FAAC-INFO

Date: April 19, 2004	Vol. # 003
Subject: 750 Drive Unit	Reason For Info: Upgraded Units

750 Drive Unit

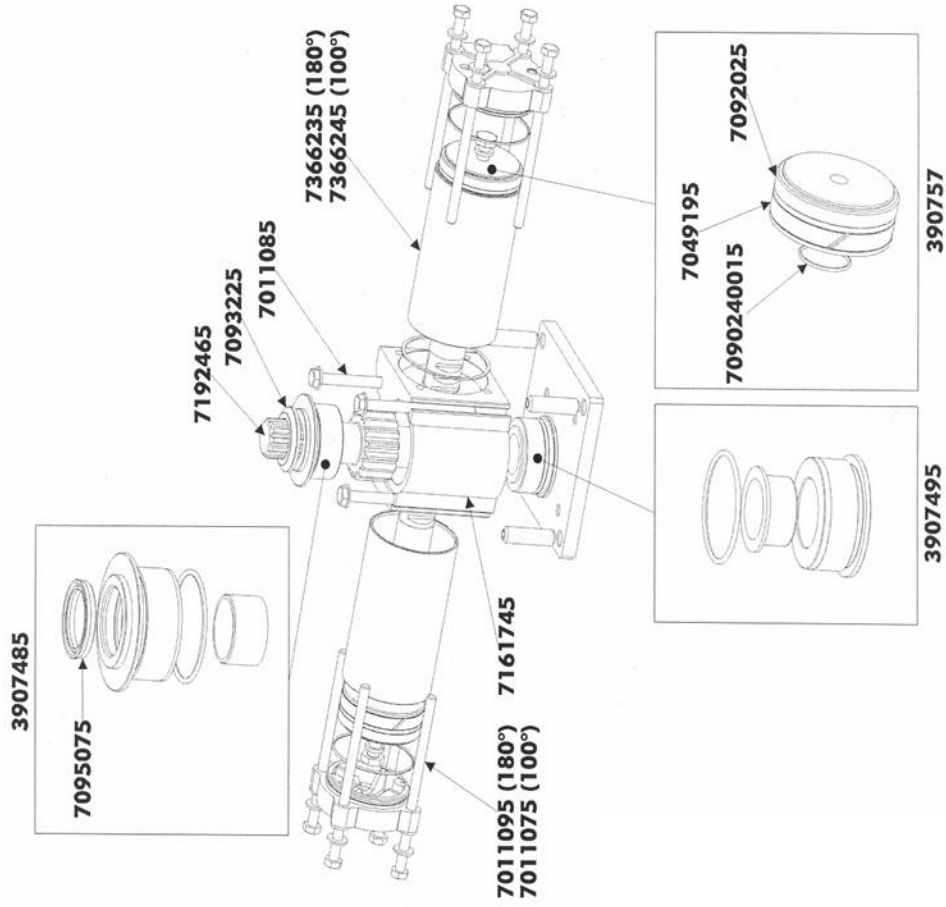
The 750 Drive units have been updated. These updates include a new type of bearing, top seal system and piston heads that resemble that of the 760 and the bolts are now stainless steel.

This upgrade has taken place on units with the serial numbers starting from 01040000 and was done on both the 100° and the 180° units.

The following picture shows the new part numbers. Use the old part number for parts that do not have a number next to them.

390635	Seal Kit (750 Drive)
3907485	Top Bushing Group
3907495	Bottom Bushing Group
7011075	Cylinder Bolts 100° = 8mm x 105mm (Stainless Bolt)
7011085	Body Bolts = 8mm x 100mm (Stainless Steel)
7011085	Cylinder Bolts 180° = 8mm x 140mm (Stainless Steel)
7083225	Top Gasket
7086075	Top Seal (Covered)
7161745	Body
7192465	Pinion Shaft
7366235	Cylinder 100° (Stainless Steel)
73662445	Cylinder 180° (Stainless Steel)
390757	Piston Assembly
7090240015	O-Ring (Rack to Piston)
7049195	O-Ring (Inner Piston Head)
7092025	O-Ring (Outer Piston Head)
